## **Attachment 4**

White Paper Prepared in Response to a Question Raised During the Audit (Nonproprietary)

CDI White Paper: 16-05NP

**Significance of Steam Dryer Fluid-Structural Interaction – CDI Perspective  
In Response to Nine Mile Point Unit 2 Audit**

Figure 2. Steam dryer section associated with hood section, hood supports and vane bank.

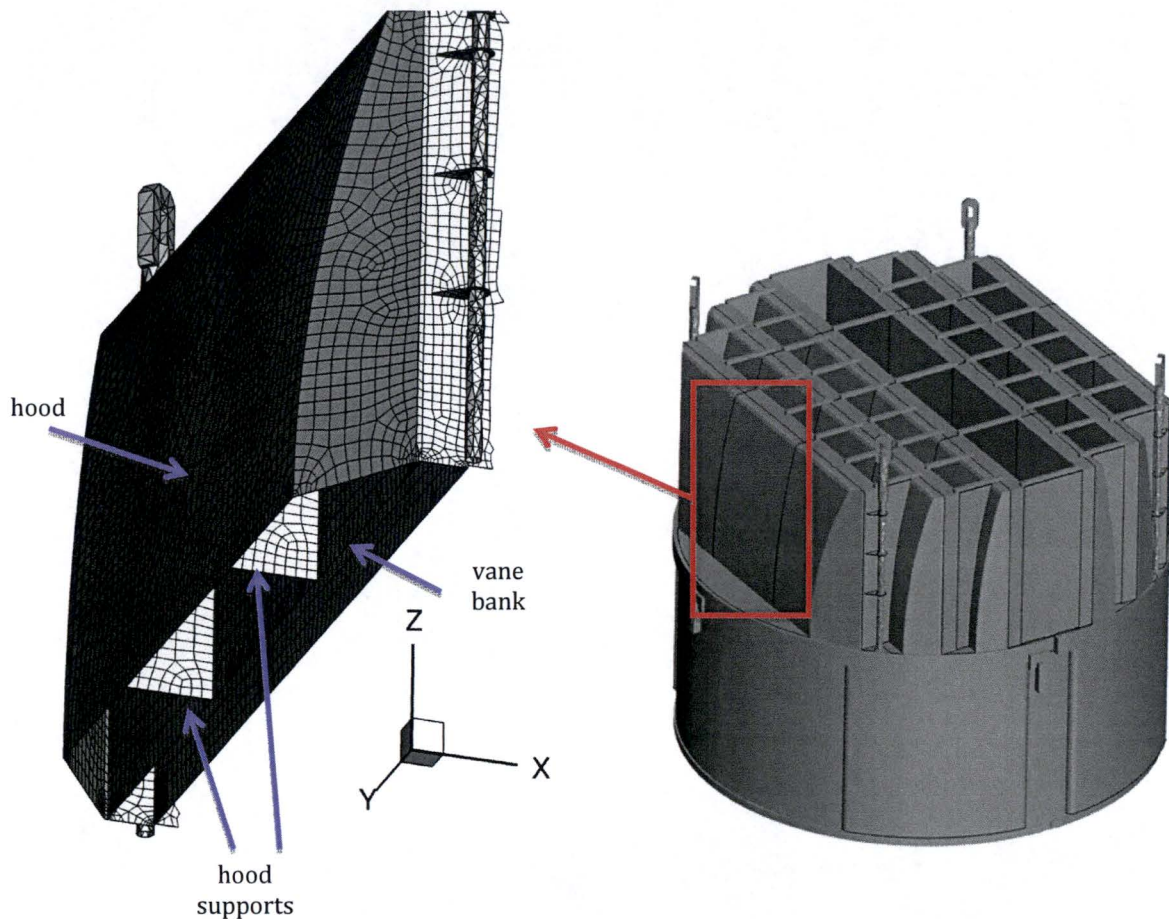
(3)]] However, during a technical review for Nine Mile Point Unit 2 with the NRC staff and consultants held at the CDI office on February 18, 2016, a presentation by an NRC consultant attempted to show that the effect of vibration-induced loading is even lower than this 42.5% value. To support this assessment, two examples involving vibrating plates in unbounded domains were referenced (see also [2]). While the solutions and acoustic behaviors of those examples are well known, CDI does not believe they are representative of the confined region acoustics of steam dryers as we aim to demonstrate below.

However, during the NRC technical review held at the CDI office on 02-18-2016, this value was challenged on the basis of two 'model' problems which would indicate that the FSI load is considerably smaller. The first model problem considers a loudspeaker in a large volume and the other examines the propagation of waves on infinite structures. Both examples are described in the

Structural Acoustics Tutorial published in Acoustics Today April 2007, particularly Part 2 of this tutorial. While the solutions and physics of these examples have long been understood, they are not representative of steam dryer geometries since they omit the effects of confinement in a closed 3D geometry.

[[

The high frequency case also reveals other nuances that arise in full 3D analysis. [[

This is explained by noting that the acoustic field supports different vertical modes at each frequency, resulting in different pressure distributions. Note too that the plots here show the real part of the complex pressure (i.e., in phase with the velocity); an imaginary component (not shown) also is present which, for this particular geometry, generally corresponds to a spring force (but in general could also include contributions from acceleration, jerk and other higher order rate terms).
